MIL-PRF-19500/684  
AMENDMENT 1  
7 June 2001

## PERFORMANCE SPECIFICATION

SEMICONDUCTOR DEVICE, TRANSISTOR, FIELD EFFECT, SILICON, N-CHANNEL,  
RADIATION HARDENED (TOTAL DOSE AND SINGLE EVENT EFFECTS)  
TYPES 2N7472U2, 2N7473U2 AND 2N7474U2  
JANTXVR AND JANSR

This amendment forms a part of MIL-PRF-19500/684, dated 6 October 2000, and is approved for use by all Departments and Agencies of the Department of Defense.

FIGURE 3. Safe operating area graph."

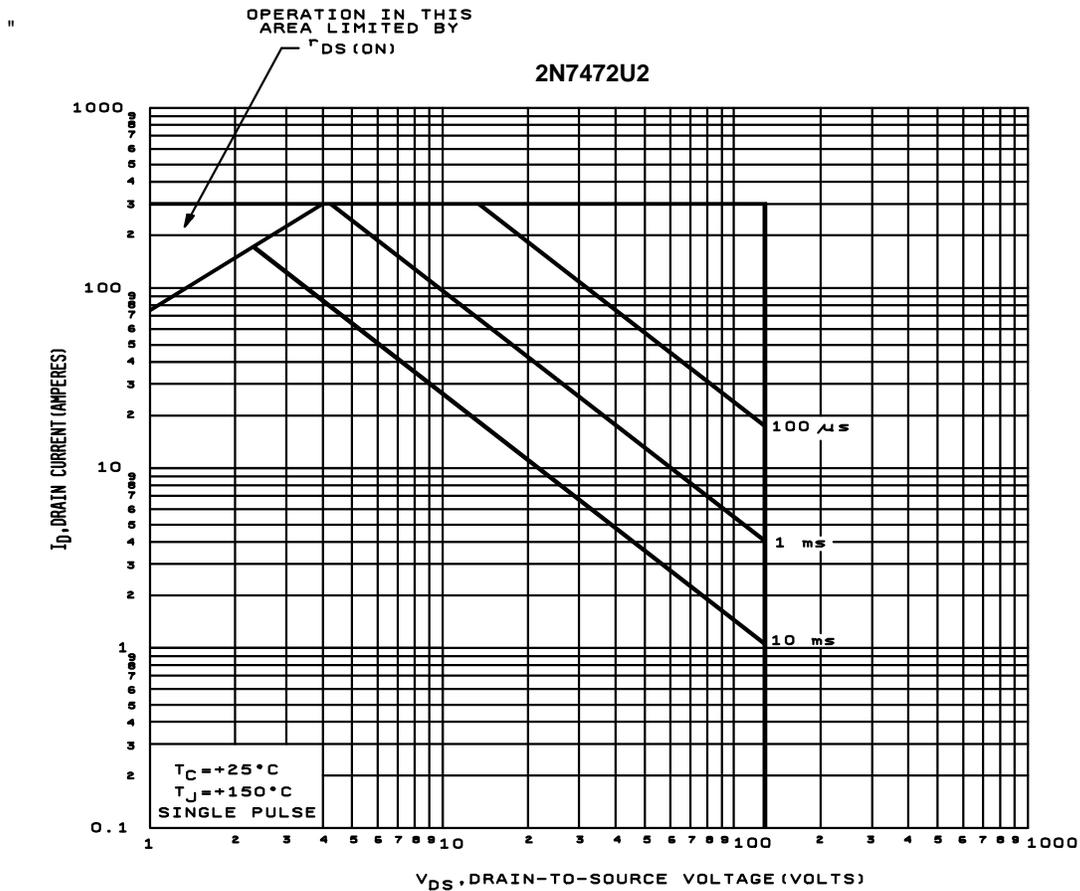
FIGURE 3, delete and substitute:

FIGURE 4. Safe operating area graph.

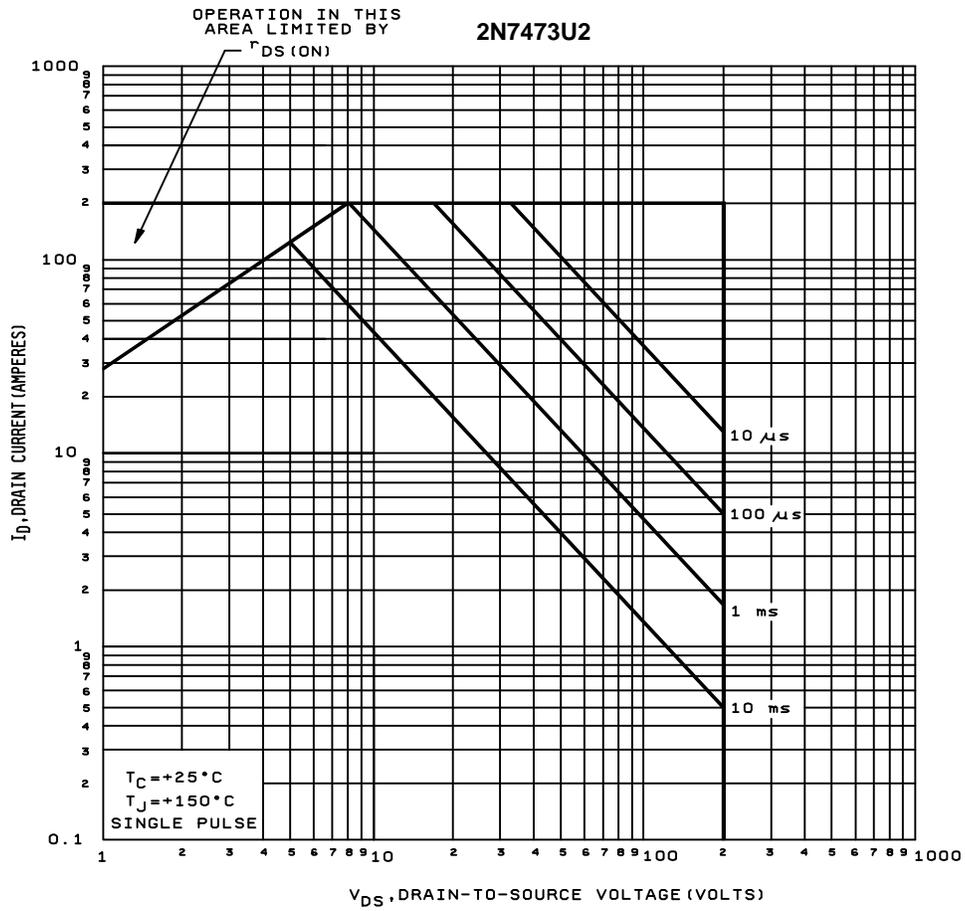
FIGURE 4, delete and substitute:

FIGURE 5. Safe operating area graph."

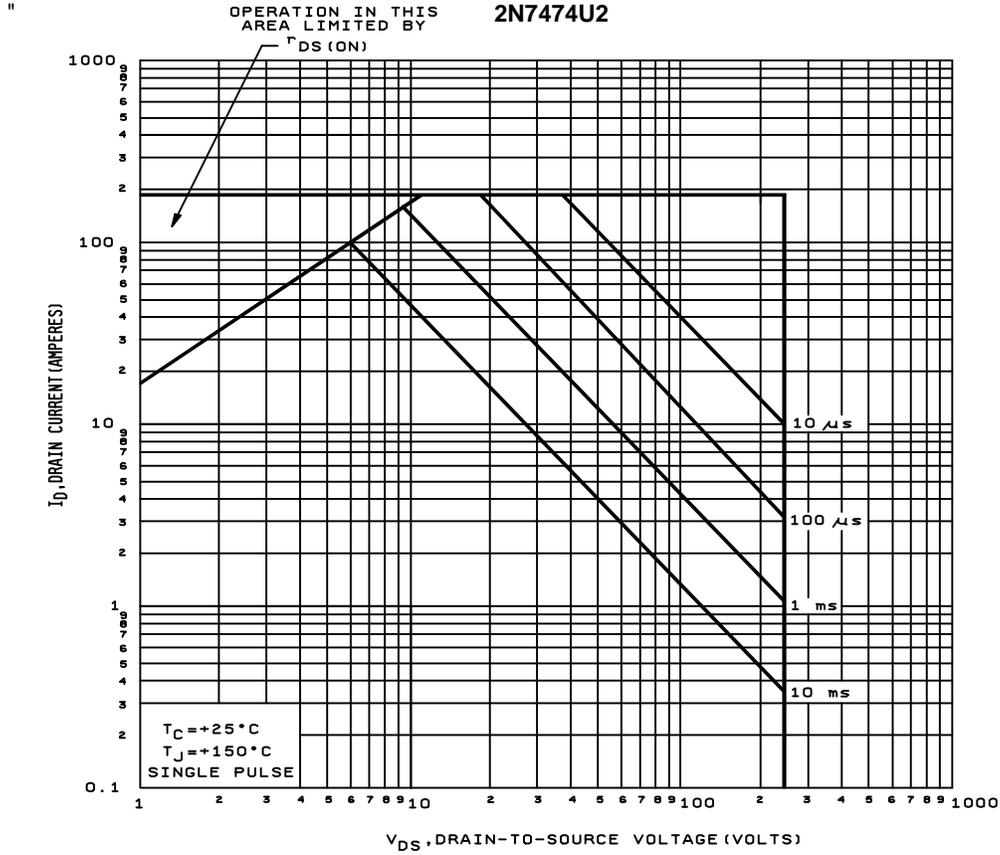
FIGURE 5, delete and substitute:
